Subject: USNRC Docket No. 71-9261; TAC No. L22085
HI-STAR 100 Transportation CoC 9261
License Amendment Request 9261-1, Supplement 2

Enclosures: 1. Replacement SAR page 2.R-7, proposed Revision 9 (1 page)
2. QUAD+ Criticality Model Sketch (1 page)
3. Mark-ups of CoC 9261, Appendix A (2 pages)

MCNP Model of QUAD+ Assembly with Dimensions

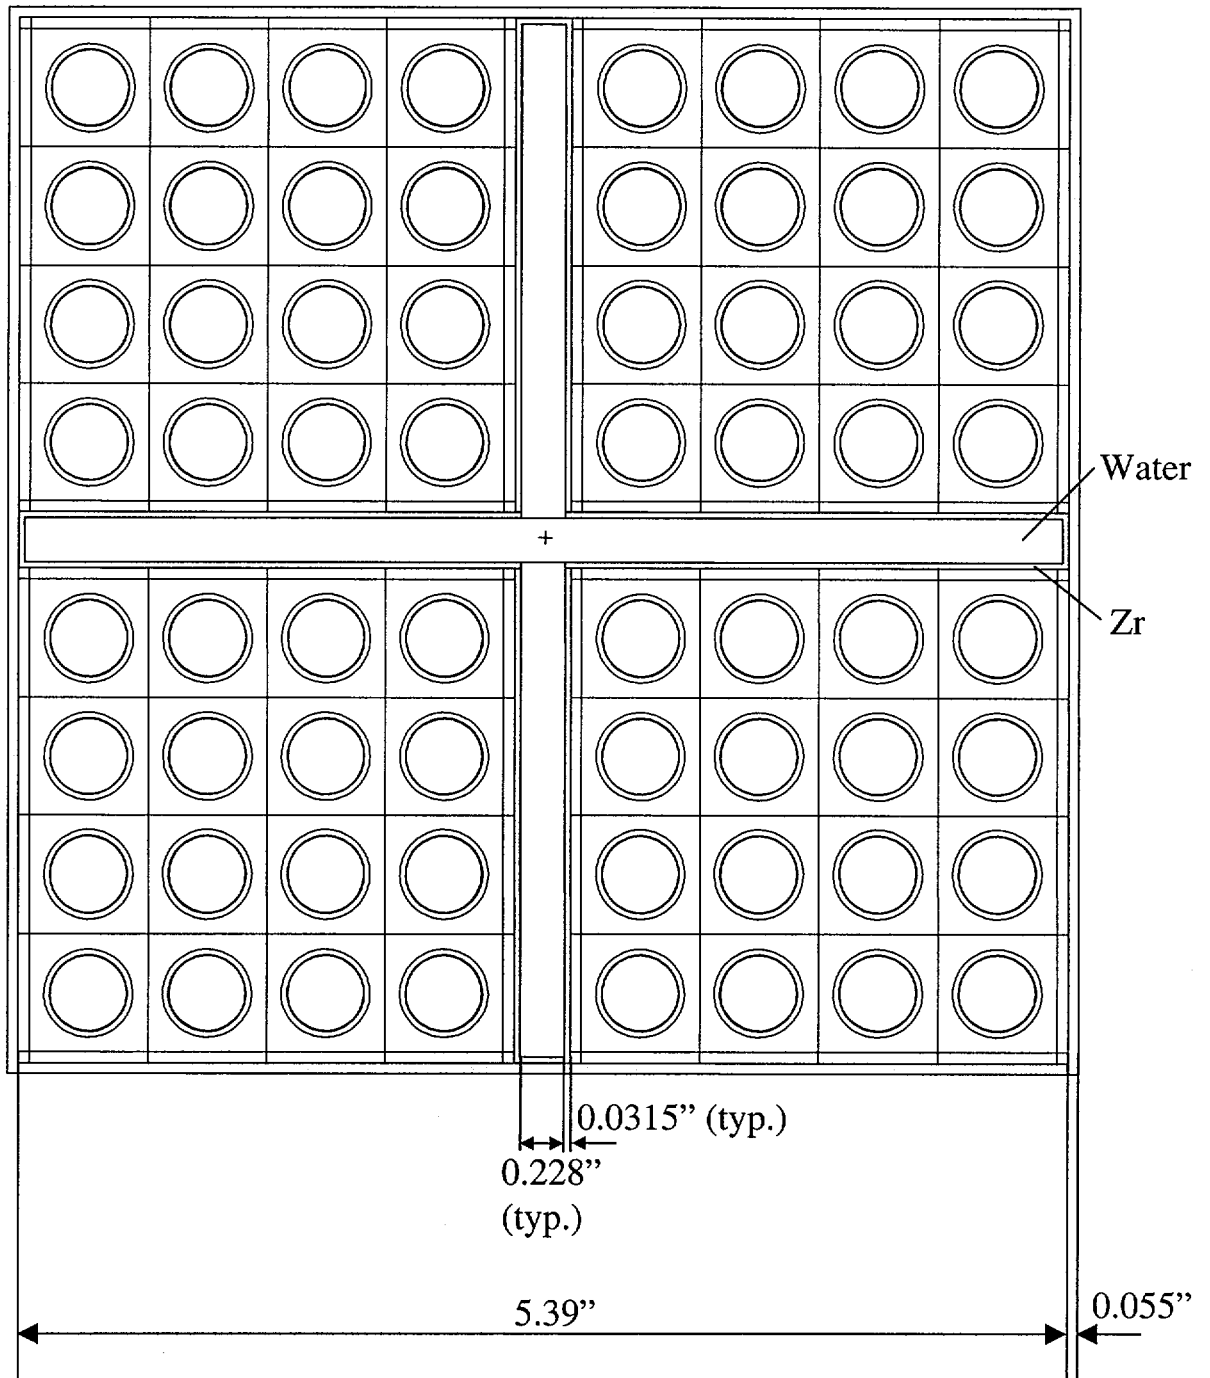
As committed during our telephone conversation yesterday, we enclose herewith replacement pages for proposed Safety Analysis Report (SAR) Revision 9, a sketch of the criticality model of the QUAD+ assembly, and revised wording for the Certificate of Compliance related to the Antimony-Beryllium neutron source. Please note that while the value of S_{by} presented in Appendix 2.R is different due to a unit conversion, the value used in the underlying calculation is unaffected and the 33% safety margin remains unchanged.
